# **SPARC Enterprise M3000/M4000/M5000/ M8000/M9000 Servers**

Product Notes for XCP Version 1117

Manual Code: C120-E721-01EN  
February 2014, Revision A

**FIGURE 6-5** Removing the Motherboard Unit

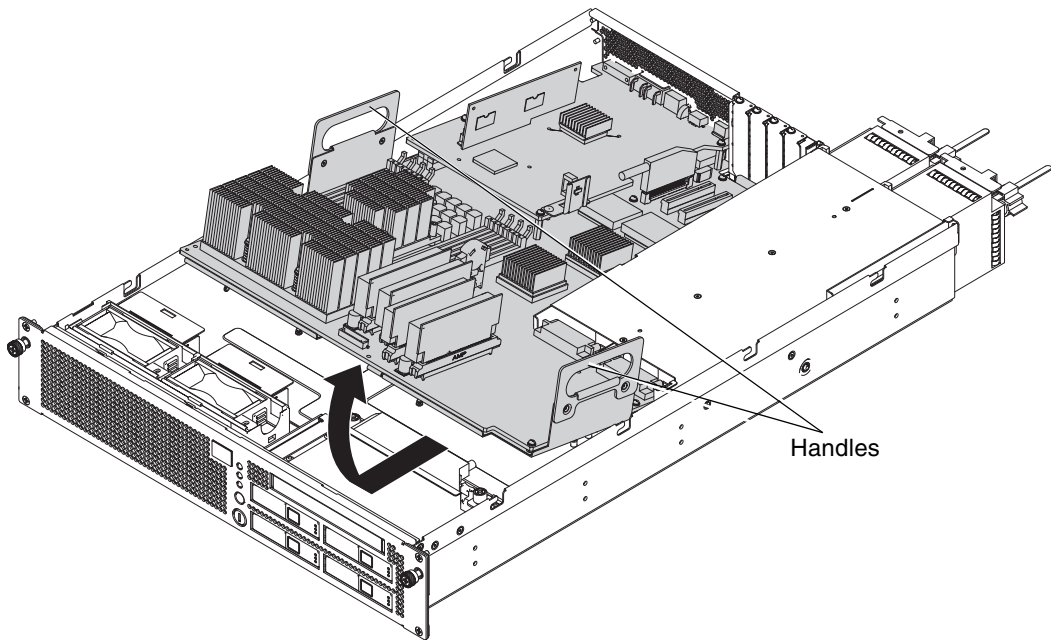
2. Hold the two opaque handles on both sides of the motherboard unit and lift the motherboard unit while sliding it out.

# M9000 Servers Installation Area

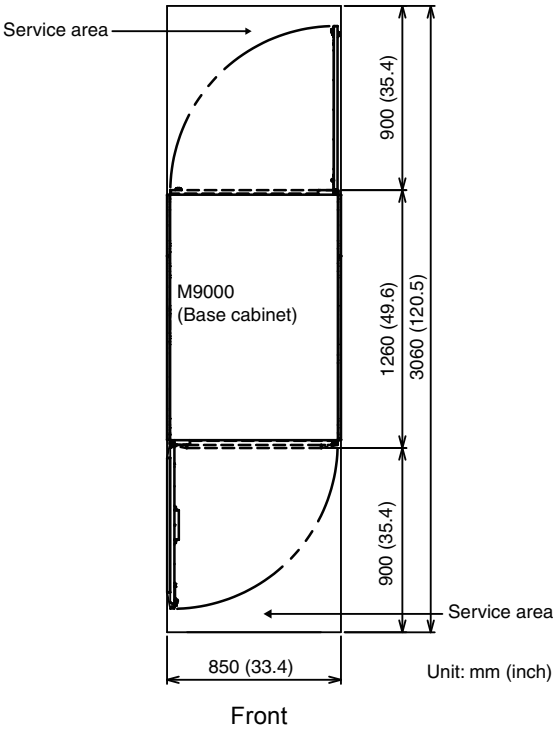
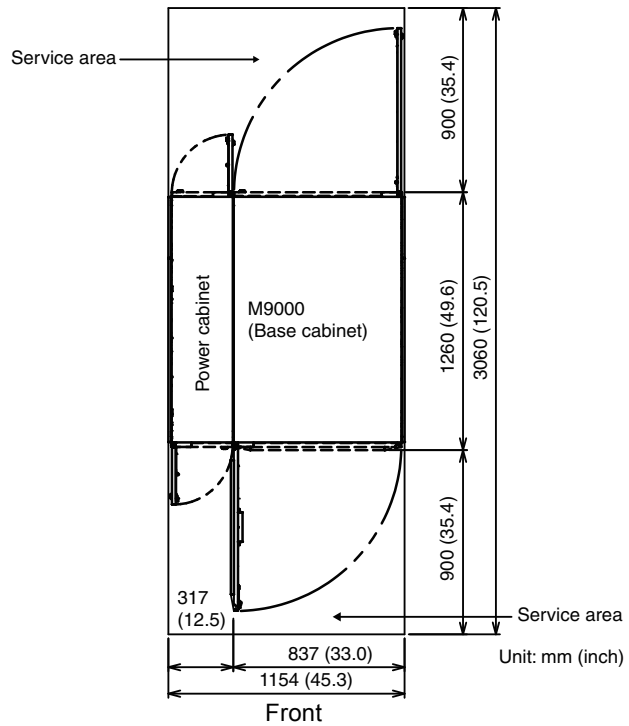
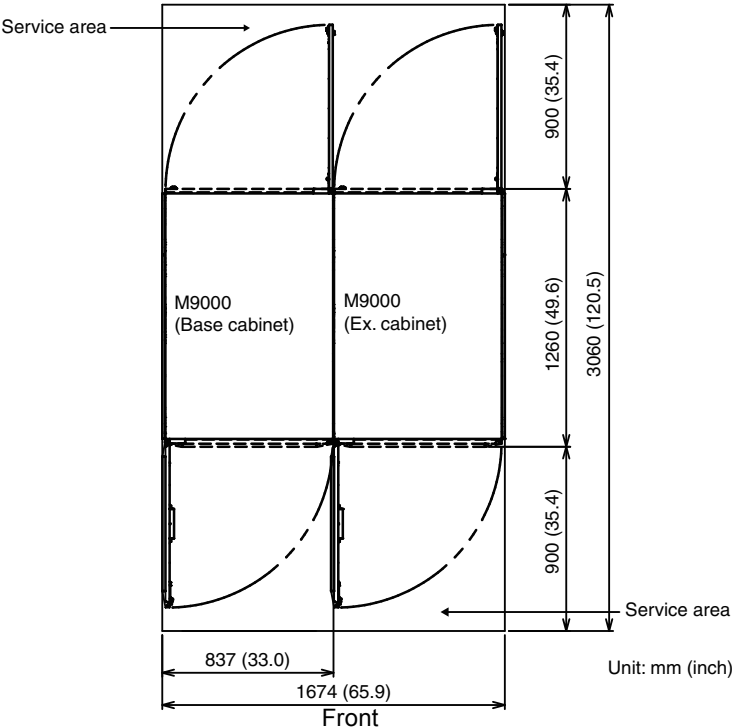
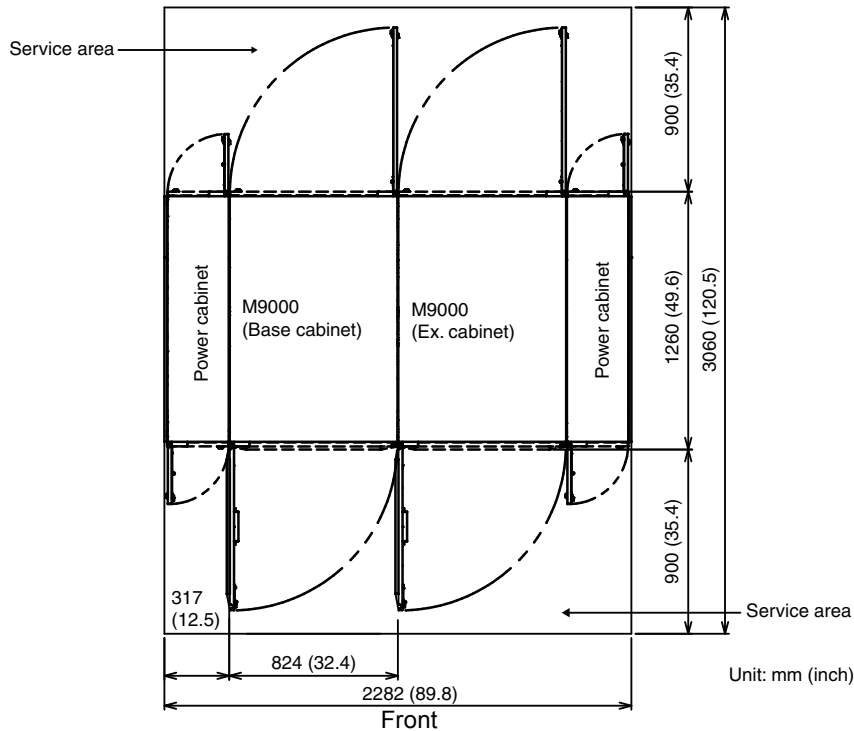
SPARC Enterprise M8000/M9000 Servers Site Planning Guide	1-18	A part of values in inches on FIGURE 1-13 to FIGURE 1-16 will be corrected. For detail, see <a href="#">“M9000 Servers Installation Area” on page 117</a> .
	1-35	For the order number of Vibration-proof bracket and Vibration-proof feet, see <a href="#">“Miscellaneous Information” on page 121</a> .
SPARC Enterprise M8000/M9000 Servers Service Manual	7-8	The mounting location of I/O Unit (IOU) indicated on FIGURE 7-4 will be corrected. For detail, see <a href="#">“I/O Unit (IOU) Mounting Locations” on page 120</a> ."

The following information supersedes the information in the *SPARC Enterprise M8000/M9000 Servers Site Planning Guide*

**FIGURE 6-2** Example of Securing the Cabinet to the Floor Surface Using the Fixing Bracket (M9000 Server)

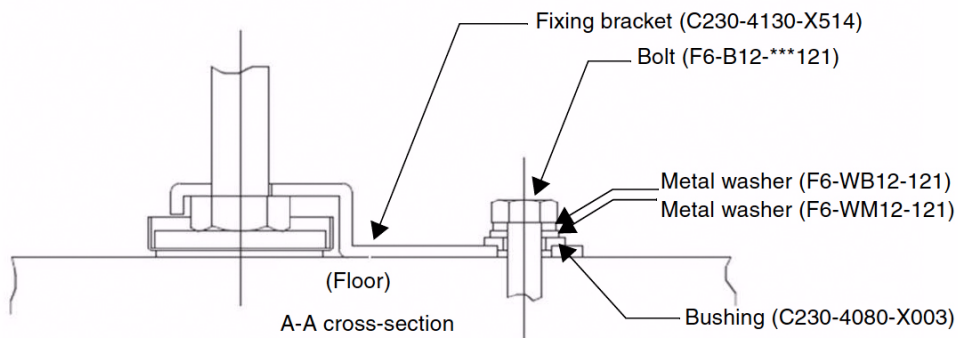
Change this board leg (height adjustment leg) to the "F6-DA6G" and tighten the bolt from under the floor.
